Subject: *McDonald's Parker – Douglas 234 Field Change Narrative 3*

This memorandum provides a summary of the field change required for the proposed McDonald's under construction at 12201 Sliceroo Drive near the intersection of Chambers Road and Hess Road in the Douglas 234 commercial development.

GRADING PLAN

C1.9

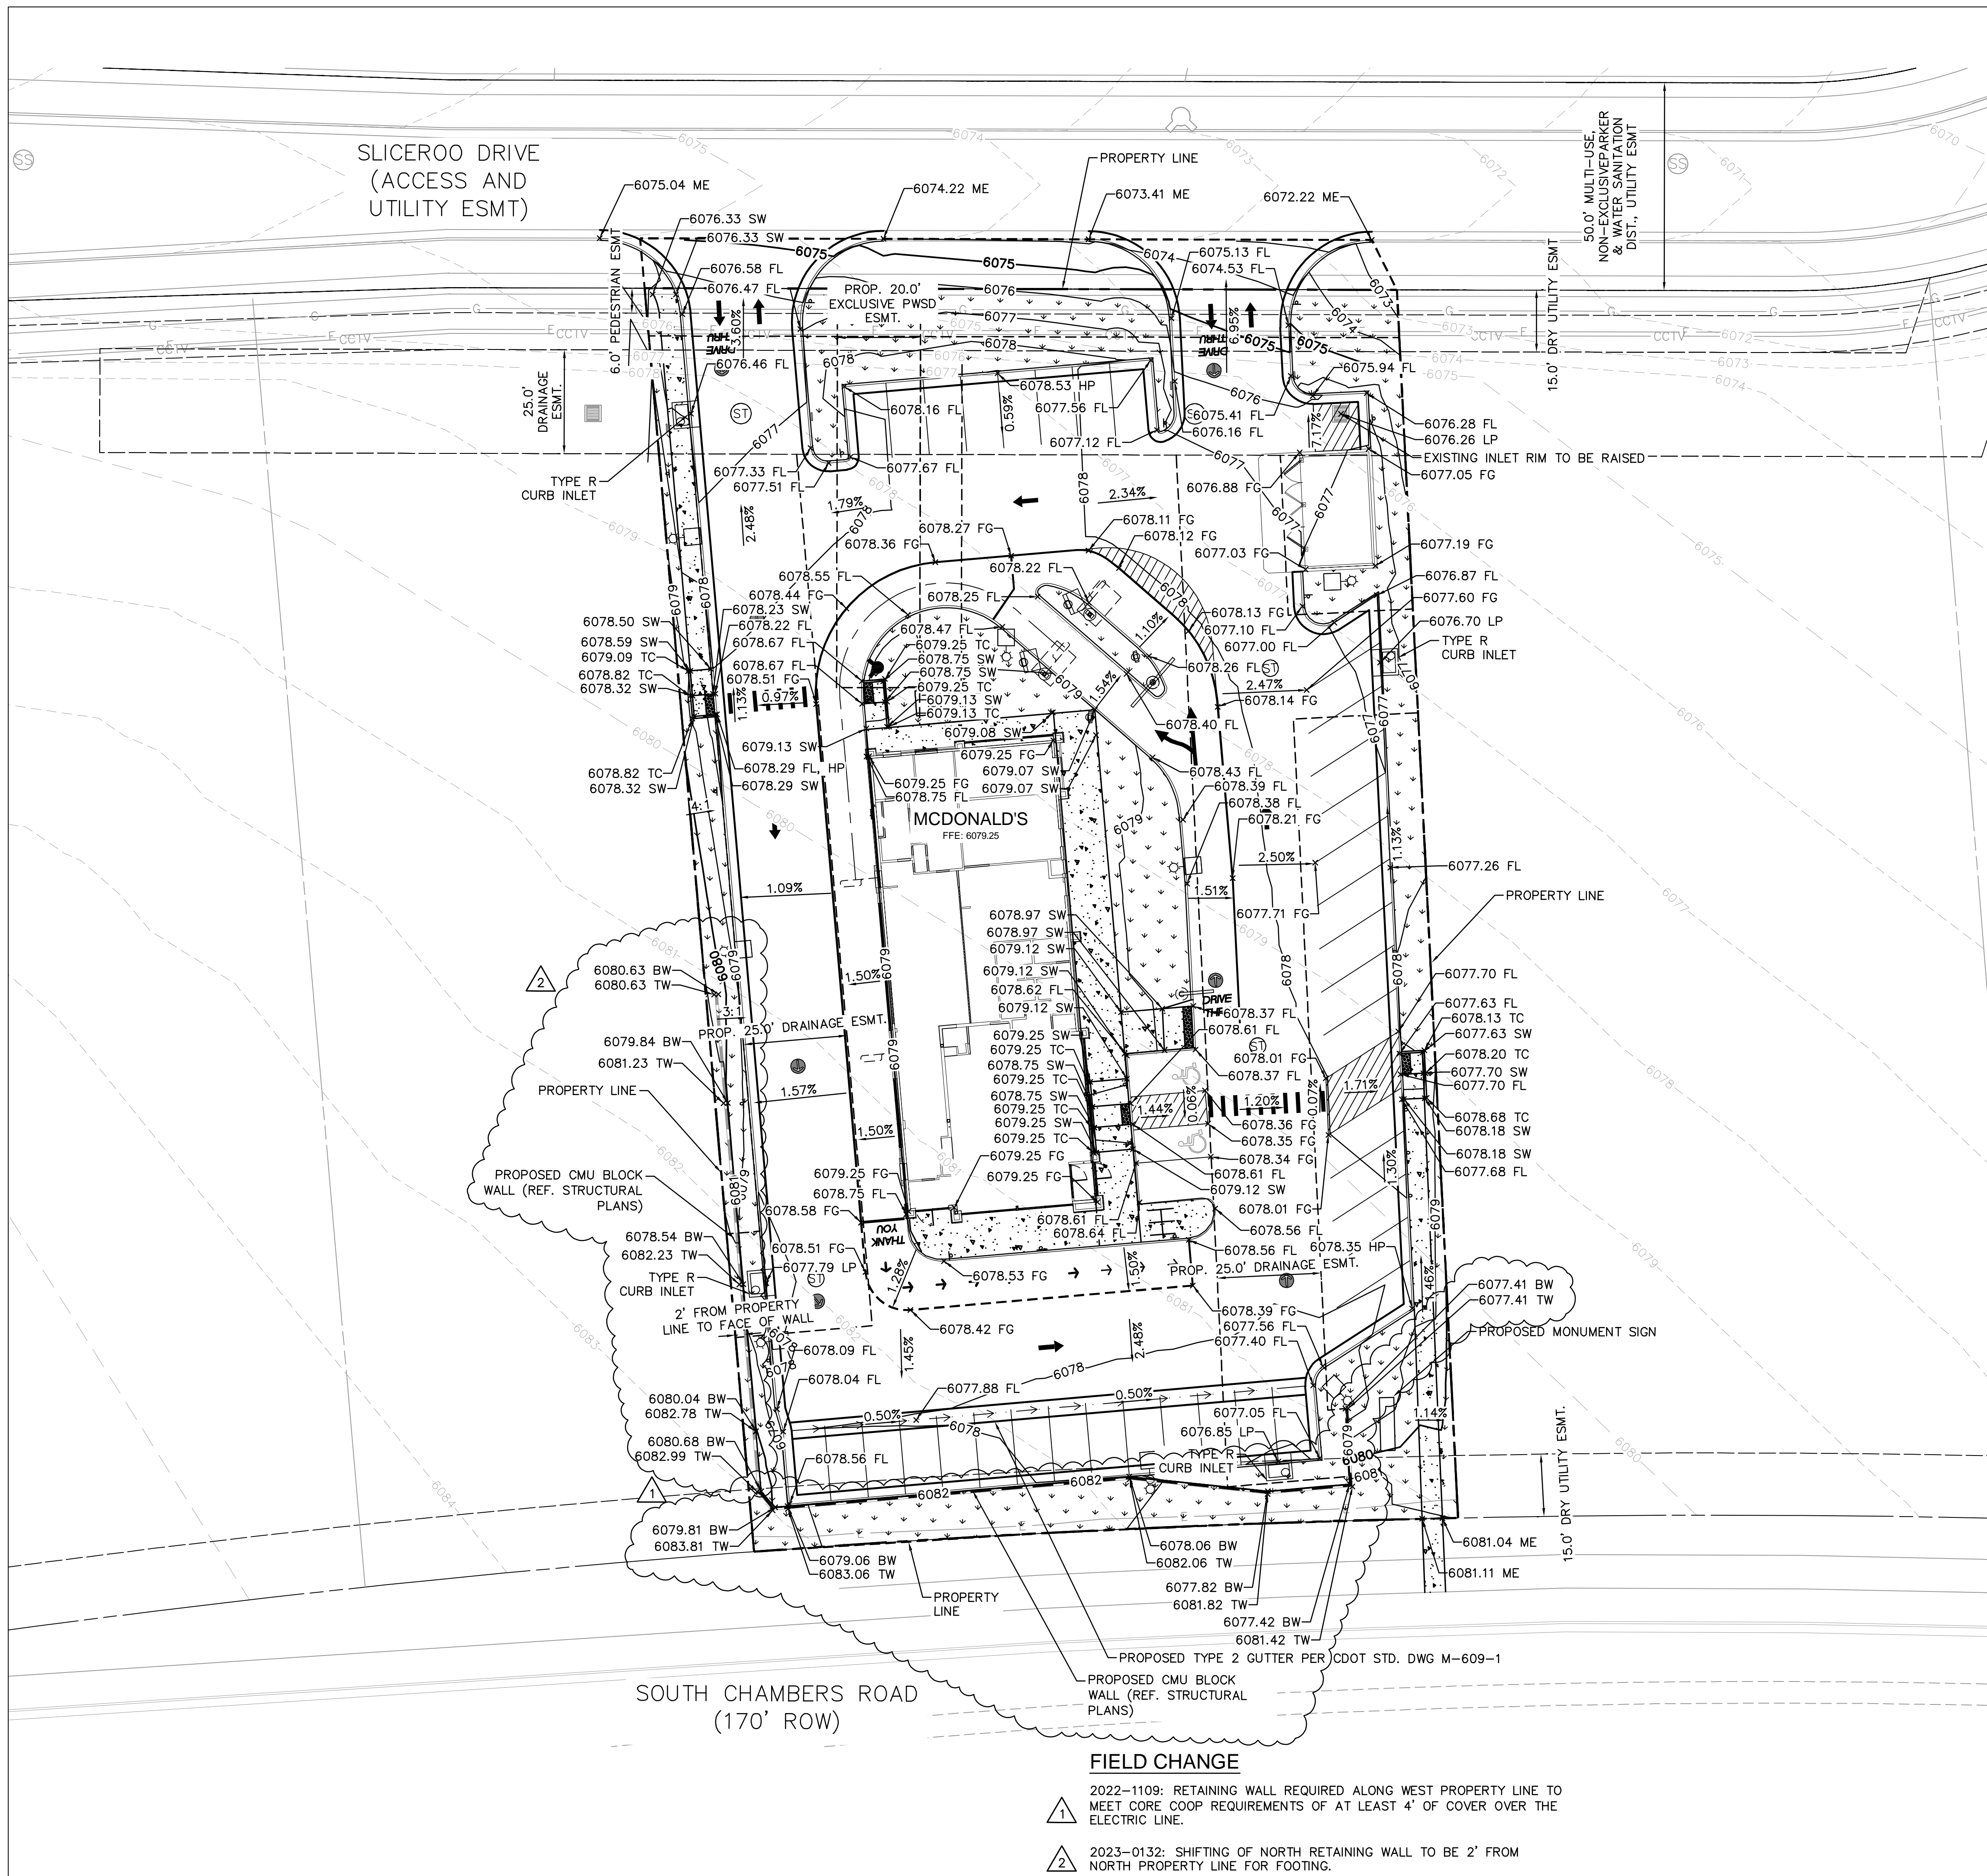
The proposed retaining wall on the north side of the Site was updated to shift to be at least 2' from the north property line so that the heel of the retaining wall remains fully on the McDonald's property. This retaining wall will be a concrete cast in place wall with a finish of the same stone material utilized for the building.

- FIELD CHANGE**
- 2022-1109: RETAINING WALL REQUIRED ALONG WEST PROPERTY LINE TO MEET CORE COOP REQUIREMENTS OF AT LEAST 4' OF COVER OVER THE ELECTRIC LINE.
 - 2023-0132: SHIFTING OF NORTH RETAINING WALL TO BE 2' FROM NORTH PROPERTY LINE FOR FOOTING.
